UNITED STATES PATENT AND TRADEMARK OFFICE

Office Action Summary	Application No. 10/568,382	Applicant(s) PAHLSSON ET AL.	
	Examiner COREY HALL	Art Unit 3743

DETAILED ACTION

Figure A.

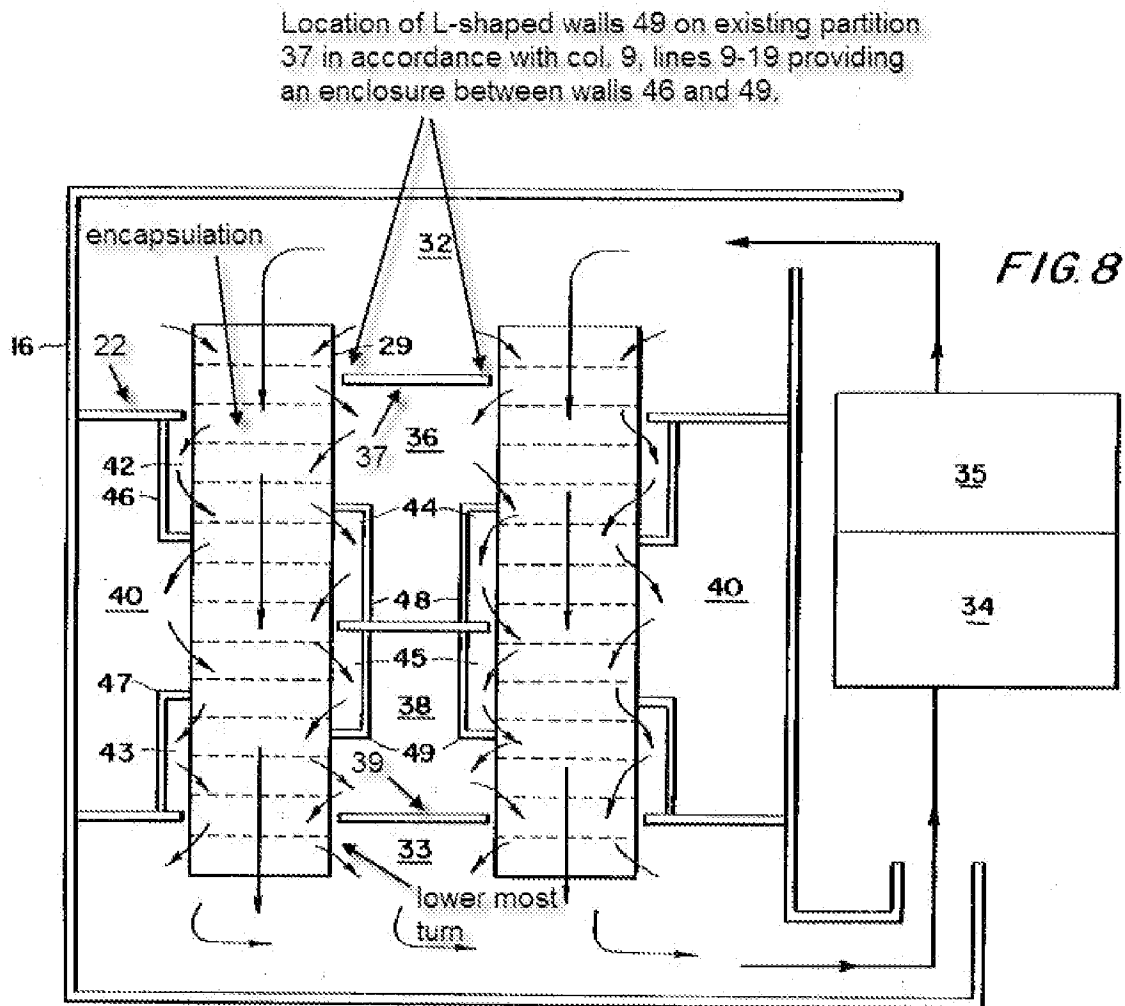
lines 32-39 describing a means for circulating the gas 34 and a means for conditioning the gas 35 and col. 10, lines 7-19 describing the means for circulating the gas 34 and means for conditioning the treatment gas 35 being used to thermally condition the gas to alter temperature or relative humidity) to said encapsulation (fig. 8 and Figure A below), said encapsulation being arranged to direct the flow of the second gaseous medium in such a manner that it is passed in the vertical direction (fig. 8 showing the second gaseous medium being directed in a vertical direction, col. 6, line 57-col. 7, line 9 describing walls being used to direct the flow of gas down through the stack) from said encapsulation to the rest of the stack, in which the first gaseous medium is humid water vapour (col. 9, lines 31-50 describing air of a particular strength or air of a specific relative humidity being supplied by pipe 51 to alter the humidity gradient in the stack and additionally being able to supply steam or spraying water to provide additional control over the relative humidity gradient of the gas flow, col. 10, lines 4-19 describing ways to control the humid water vapor in the apparatus and col. 10, lines 45-55 describing the apparatus providing greater control over the conditioned gas and where the language humid water vapour is not clearly defined in Applicant's Specification), in which said encapsulation (fig. 8 and Figure A below) is arranged at the upper part of the stack (29, fig. 8), in which a second end closure (37, fig. 8 and Figure A below) is arranged over the central space (38, fig. 8), in which lateral pieces (fig. 2 showing a stack having a longitudinal edge forming an outer wall of the stack 20 which is almost identical to Applicant's Figure 1 at 7b) at a longitudinal edge of the conveyor belt (19, fig. 2) form an outer wall of the stack (20, fig. 2), which defines the stack outwards in the radial direction (fig. 2), in which lateral pieces (fig. 2 showing a stack having a longitudinal edge forming an inner wall of the stack 20 which is almost identical to Applicant's Figure 1 at 7a) at a

longitudinal edge of the conveyor belt (19, fig. 2) form an inner wall of the stack (20, fig. 2) which defines the stack inwards in the radial direction to define said central space (fig. 2 showing an inner wall of the stack defining the central space), in which a third end closure (39, fig. 8 and Figure A below) is arranged against the lowermost turn (fig. 8 and Figure A below) formed in the stack, said third end closure being arranged transversely of the central space defined by the conveyor belt (fig. 8 and Figure A below showing the third end closure 39 being transversely arranged of the central space), in which the conveying direction of the conveyor belt (19, fig. 1 showing the conveyor belt 19 entering at an inlet 17 and moving in an upward direction toward the encapsulation to an outlet 18 which is similar to Applicant's Figure 2) is arranged towards the encapsulation, in which the stack (20, fig. 1) is arranged in a housing (16, fig. 1) comprising an inlet (17, fig. 1) and an outlet (18, fig. 1) for the conveyor belt (19, fig. 1), in which the encapsulation (fig. 8 and Figure A below) has one outer (46, fig. 8 and Figure A below) and one inner (49, fig. 8 and Figure A below) circumferential wall having the same height (fig. 8 and Figure A below showing the outer and inner walls having the same height), vertically surrounding a portion of the stack (29, fig. 8), a method for treating foodstuffs (fig. 1, "treat other particulate solid materials, e.g., food" col. 1, lines 8-10 describing the apparatus being used to process and dry materials including food) for the purpose of processing and drying, comprising: (a) providing an endless conveyor belt (19, fig. 2, col. 5, line 46) which along part of its length follows a helical path to form a stack (20, fig. 2, col. 5, line 50), said conveyor belt having passages for letting a flow of a gaseous medium through the stack in the vertical as well as the horizontal directions (fig. 8, col. 6, lines 40-56 describing the conveyor belt having passages for letting a flow of gaseous medium in the vertical as well as horizontal direction),

wherein: (i) the stack defining a central space (38, fig. 9), and (ii) the stack comprising a lower non-encapsulated stack portion (40, fig. 8) and, adjacent thereto, an upper stack portion (29, fig. 8) which is encapsulated in the vertical direction by an encapsulation (fig. 8 and Figure A below) that is essentially tight in the horizontal direction, the encapsulation being formed by an outer circumferential wall (46, fig. 8 and Figure A below, col. 9, lines 9-19 describing L-shaped walls being attached to the partitions which would include partition 22 to create additional chambers) and an inner circumferential wall (49, fig. 8 and Figure A below showing locations on the existing partition 37 where L-shaped wall 49 can be attached, col. 9, lines 9-19 describing L-shaped walls being attached to the existing partitions which would include partition 37) vertically surrounding the upper stack portion (29, fig. 8), (b) supplying a flow of a first gaseous medium (col. 9, lines 21-50 describing gas being fed through first supply 51 including air of specific relative humidity and steam) to said central space (38, fig. 9) for further conveyance to the non-encapsulated stack portion (40, fig. 9) through said passages for letting through a flow of a first gaseous medium in the horizontal direction, (c) supplying a flow of a second gaseous medium (fig. 8 showing a second gaseous medium from the means for circulating the gas 34, col. 7, lines 32-39 describing a means for circulating the gas 34 and means for conditioning the gas 35) to said upper encapsulated stack portion (29, fig. 8), (d) wherein said encapsulation (fig. 8 and Figure A below) directing the flow of the second gaseous medium in such a manner that it flows in an essentially vertical direction (fig. 8 showing the flow of the second gaseous medium in an essentially vertical direction) from said encapsulated stack portion (29, fig. 8) to said non-encapsulated stack portion (40, fig. 8), and (e) the flow of the second gaseous medium (fig. 8), which enters the encapsulated stack portion and flows essentially vertically downwards (fig. 8

15. In regards to claim 6, Crump et al. discloses the claimed invention including an encapsulation (Crump et al., fig. 8 and Figure A above), except for in which a first end closure is arranged to cover the conveyor belt at the upper edge. However, Kaufman teaches a first end closure (42, fig. 4, “conical hood 42” col. 4, lines 61-64) is arranged to cover a conveyor belt (40, fig. 4, “spiral conveyor 40” col. 4, line 62) at an upper edge (fig. 4 showing end closure 42 at an upper edge) in order to direct an air flow to an upper portion of a helical conveyor (col. 4, line 61-col. 5, line 2). Therefore, it would have been obvious to one of ordinary skill in the art at the time of invention was made to modify the Crump et al. reference, to include in which a first end closure is arranged to cover the conveyor belt at the upper edge, as suggested and taught by Kaufman, for the purpose of directing an air flow to an upper portion of a spiral conveyor. The Applicant is combining prior art elements according to known methods to yield predictable results. The Applicant is combining the prior art elements of a helical conveyor for processing foodstuffs using upper and lower sections as disclosed by Crump et al. with the prior art elements of a helical conveyor for processing foodstuffs using upper and lower sections where processing gas is directed to the upper section through a first end closure arranged to cover a conveyor belt at an upper edge as taught by Kaufman according to known methods to yield the predictable results of a helical conveyor for processing foodstuffs using upper and lower sections where processing gas is directed to the upper section through a first end closure arranged to cover a conveyor belt at an upper edge. One would be motivated to combine Crump et al. with Kaufman because Kaufman teaches using a first end closure to cover a conveyor belt at an upper edge to better direct processing gas to an upper section of a helical conveyor and Crump et al. could be similarly improved to better direct processing gas to the upper section of its helical

17. In regards to claim 16, Crump et al. discloses the claimed invention including an encapsulation (Crump et al., fig. 8 and Figure A above), except for in which the encapsulation has one outer circumferential wall extending vertically along the full height of the stack, and one inner circumferential wall extending vertically along a portion of the stack, whereby said outer circumferential wall optionally has openings or perforations along the portion of the stack not covered by the inner circumferential wall. However, Lang et al. teaches an encapsulation (fig. 16 at 203) having one outer circumferential wall (219, fig. 16 showing an outer circumferential wall extending vertically along the full height of the stack) extending vertically along the full height of the stack (203, fig. 16), and one inner circumferential wall (225, fig. 16 showing an inner circumferential wall extending vertically along a portion of the stack) extending vertically along a portion of the stack (203, fig. 16), whereby said outer circumferential wall (219, fig. 16) optionally has openings (223, fig. 16) along a portion of the stack (203, fig. 16) not covered by the inner circumferential wall (225, fig. 16) in order to provide a more vertical flow of the gas through the conveyor (col. 13, lines 1-12). Therefore, it would have been obvious to one of ordinary skill in the art at the time of invention was made to modify the Crump et al. reference,
